**Environmental Impact Assessment (EIA) Ordinance, Cap.499  
Environmental Permit (EP) No. EP-570/2019  
TKO Connect Cable System  
EP Condition 2.1 – Changes to Cable Alignment**

### **Proposed Changes to the Project**

Figure A Original and Revised TKO Connect Alignments and Control Points Coordinates

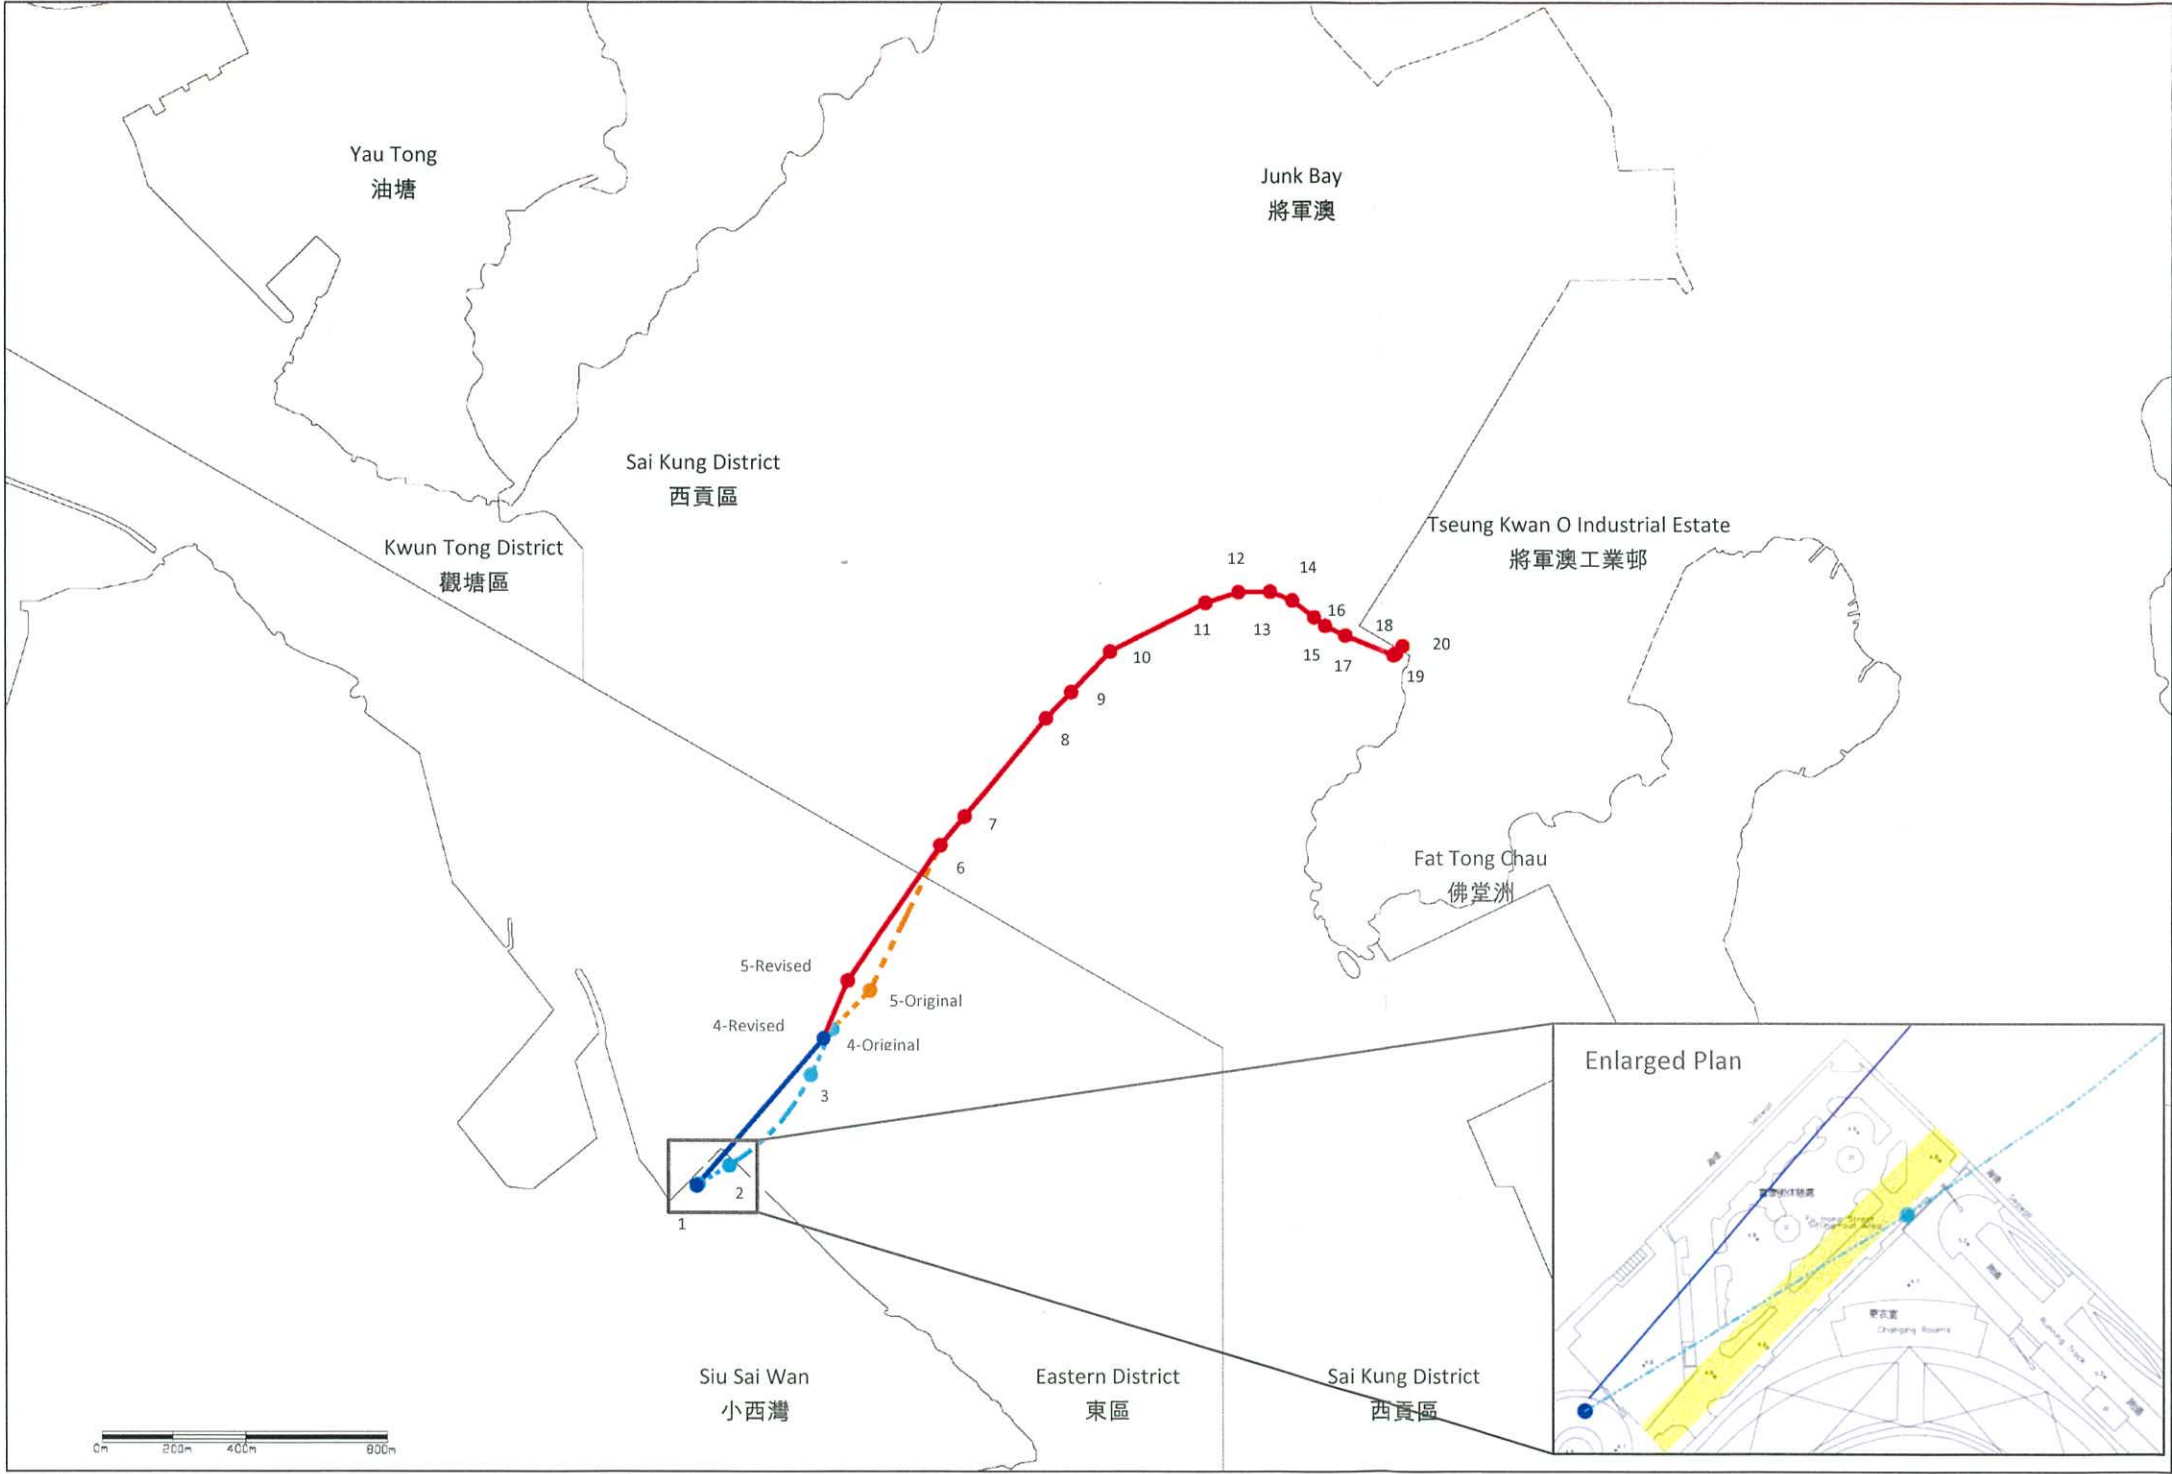
- **Cable Alignment:** To address DSD's comment regarding their Drainage Reserve, adjustments were made to the section of TKO Connect to be installed by HDD at Siu Sai Wan. The attached **Figure A** shows a comparison between the original and revised TKO Connect cable alignment. In the original alignment, Points 1 to 4 represent the first section of the cable alignment to be installed by HDD (shown in light blue as a curved trajectory), followed by the latter section (shown in red) to be installed by cable laying vessel. Adjustments were made at Point 1 where the HDD punch-in point was proposed to be shifted by 6.9m towards the southwest. In addition, the curved trajectory of the HDD section has been straightened to avoid encroaching into the Drainage Reserve, hence the number of control points for the HDD section have reduced and thus the HDD seabed break out point at Point 4 was proposed to be shifted by 35.6m towards the southwest. To ensure smooth installation at the revised HDD seabed break out point by the cable laying vessel, Point 5 was proposed to shift west by 27.8m. A zoomed in drawing showing the proposed changes is provided in the attached **Figure B**.

Figure C Seabed Feature of Revised TKO Connect

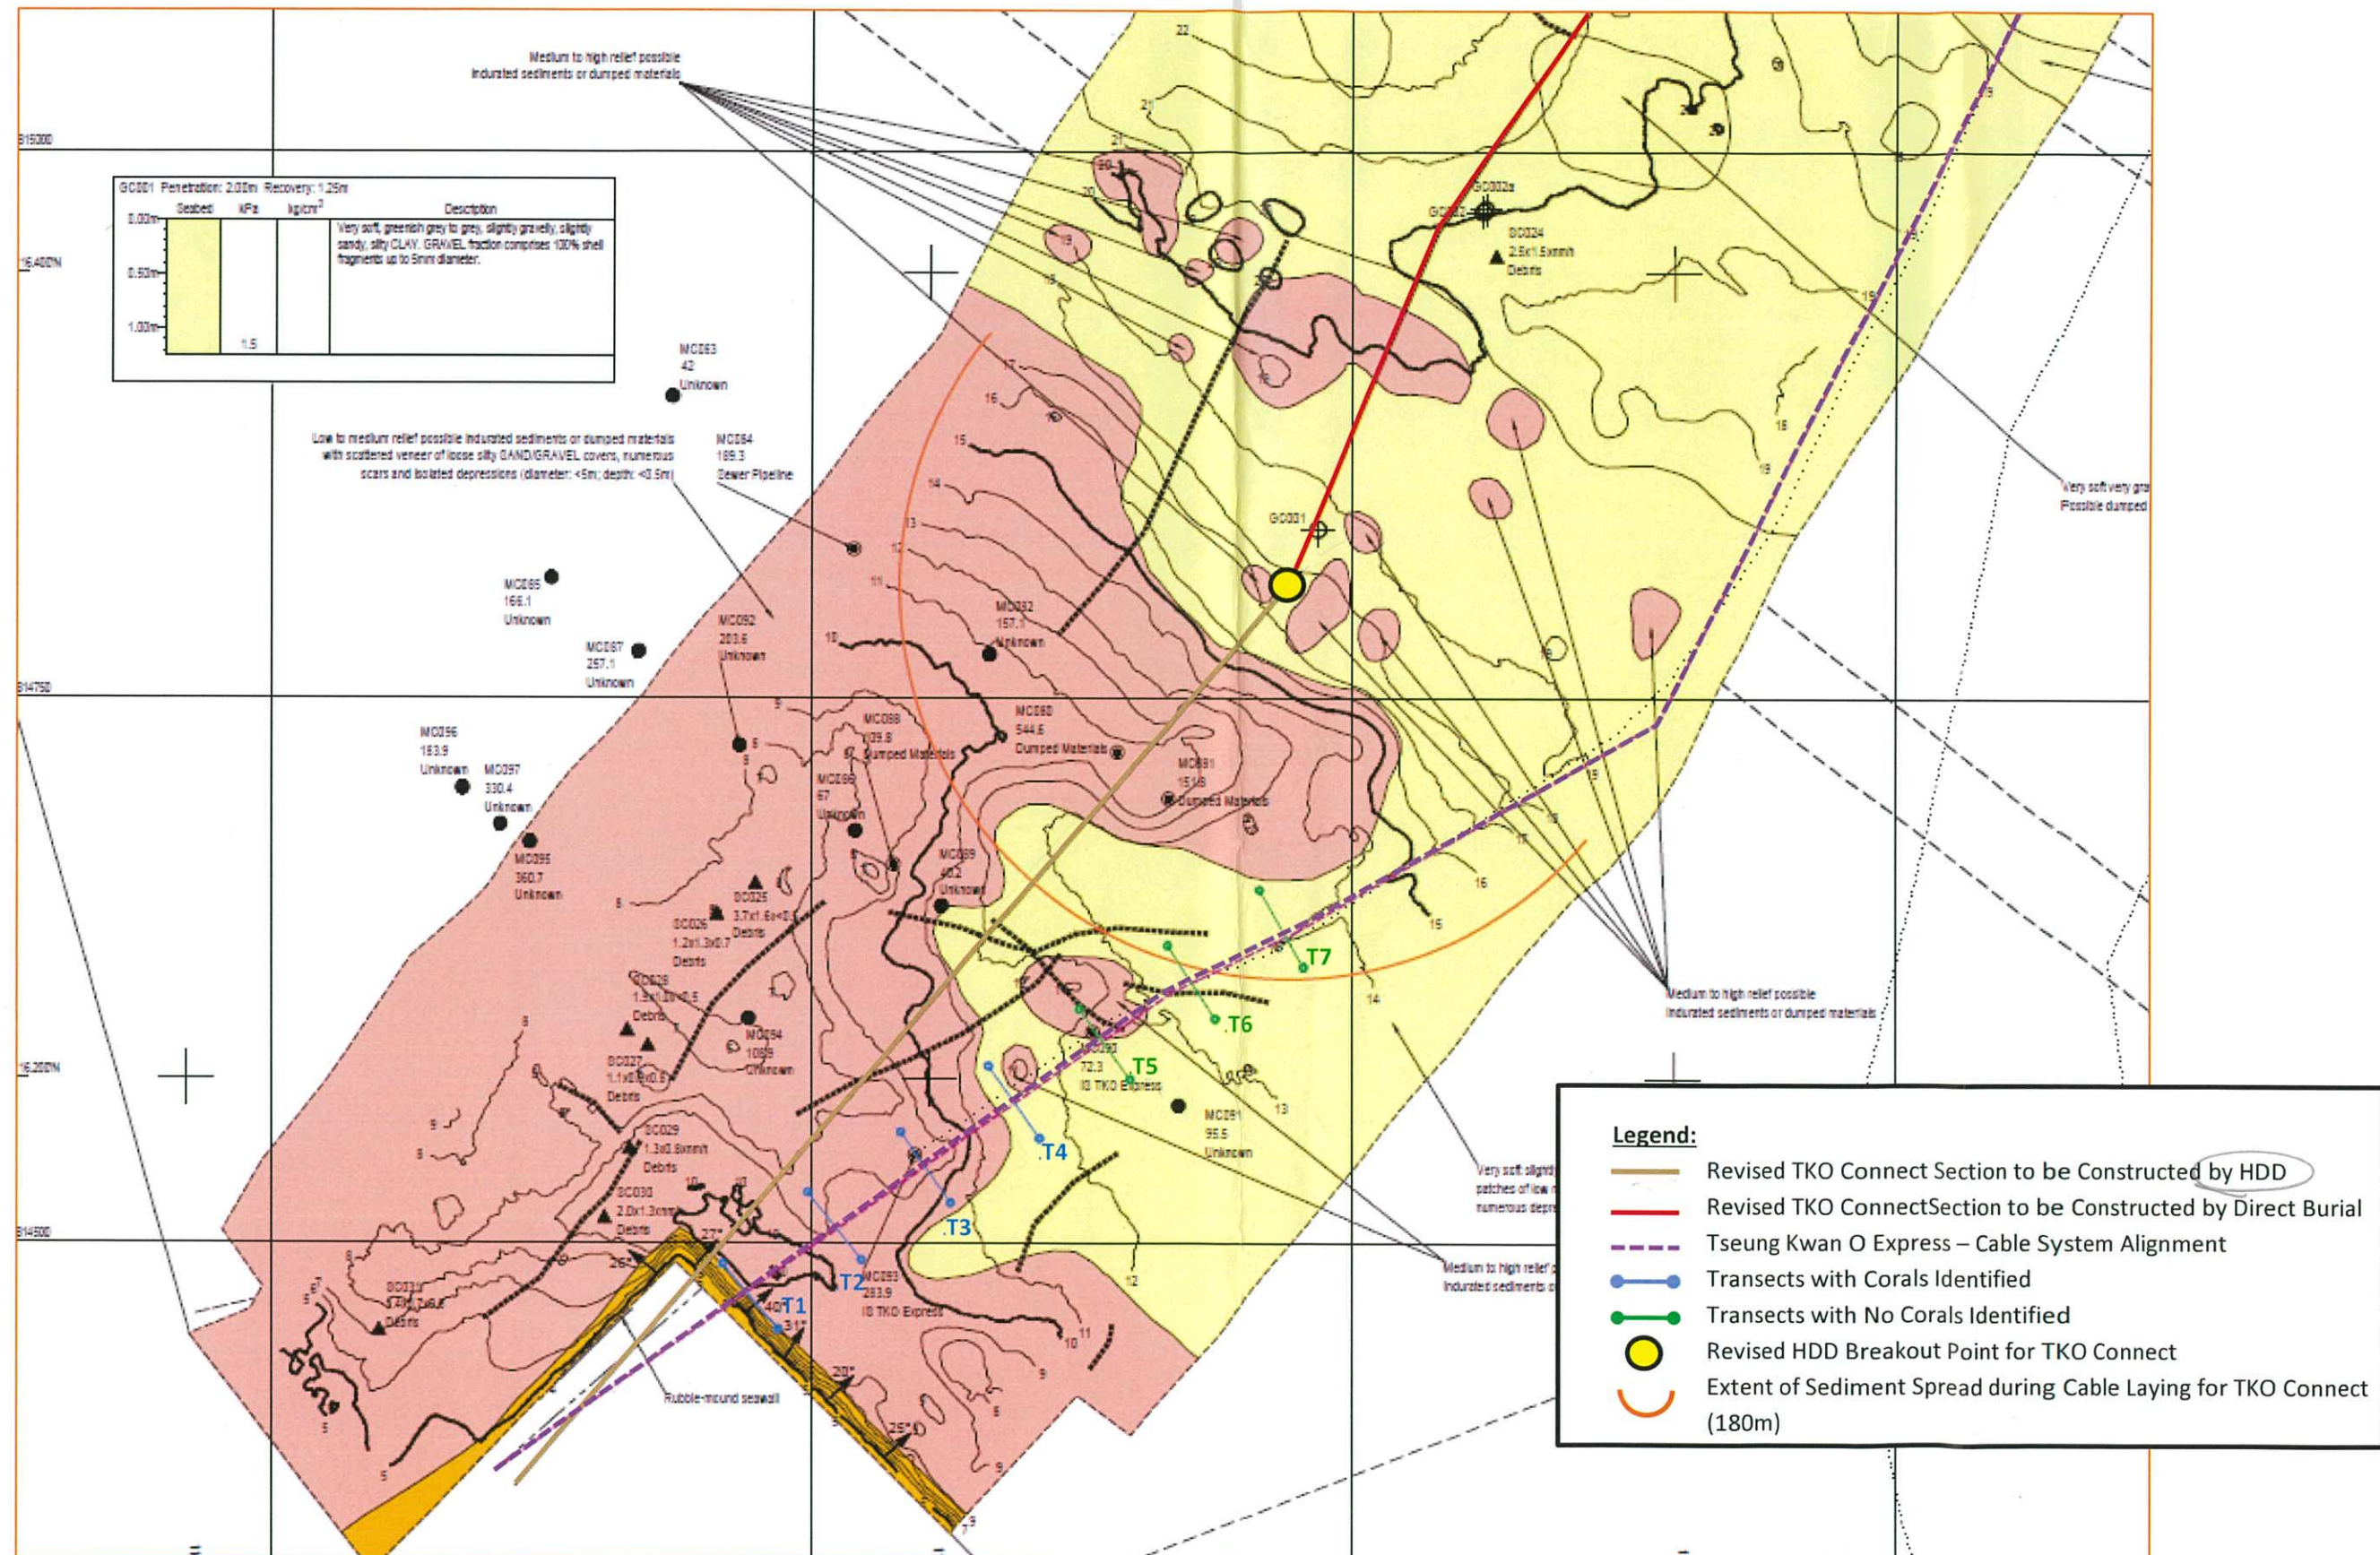
The revised cable alignment will be with a straightened HDD section and punch out point slightly shifted towards the west. As confirmed by geophysical/dive survey conducted in January 2018, the HDD break out location lies in an area with dumped material composed of soft marine mud that was being dredged previously, which is considered to be very soft materials and not suitable for coral or octocoral growth. Our dive survey also confirmed that no coral was identified at the revised HDD break out location and along the TKO Connect alignment to be installed by direct burial. As concluded in the water quality assessment in Annex A of the approved Project Profile, the extent of sediment spread from the cable laying work shall be 180m. As shown in the attached **Figure C**, coral were only observed from transects T1 to T4 during coral dive survey for TKO Express – Cable System, no hard coral or octocorals were recorded at any of the transects from T5 onwards at more than 250m offshore. As indicated in **Figure C**, no coral shall be indirectly impacted during cable installation at the revised cable alignment. The approved Project Profile also confirmed that Victoria Harbour is not considered to represent an important habitat for the Indo-Pacific Humpbacked Dolphin or the Finless Porpoise and disturbance to these marine mammal species is not expected. No other species of conservation importance was identified along or in the vicinity of the revised cable alignment. It is not anticipated that the revised alignment will cause any adverse marine ecology impact. Section 4.4 and Annex C of the approved Project Profile still remains valid and will not be affected by the change in alignment
